DS-K1T671 Series MinMoe Terminal Release Notes (2020-04-09)

Device Model: DS-K1T671M/MF DS-K1T671TMW/TMFW	Firmware Version	ARM :ACS_671_AI3_EN_GM_V3.1.0_build200331 MCU :ACS_DS-K1T671_ST1_GML_GM_V1.0.1_build200331	
Naming Rule: M for M1 card, W for WIFI, F for fingerprint	SDK	HCNetSDKV6.1.0.25_build20190718_Win32_EN HCEhomeSDKV2.2.1.1_build20190410_win32	
	iVMS-4200 Client Version	iVMS-4200 AC(V1.0.3.11_E).exe

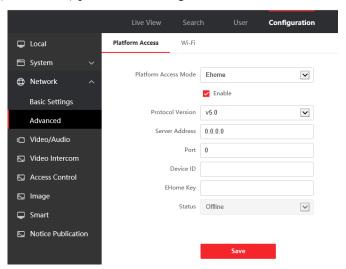
3. Login and configure device in web client via browser to realize person management, parameter configuration, log search and system maintenance;

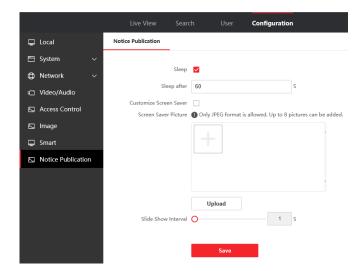
4. Support encryption (4 to 6 characters, optional) for USB import and export data.

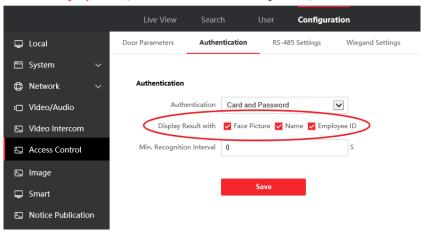
5. Support ISUP 5.0(EHome 5.0) protocol to manage devices located in different locations;
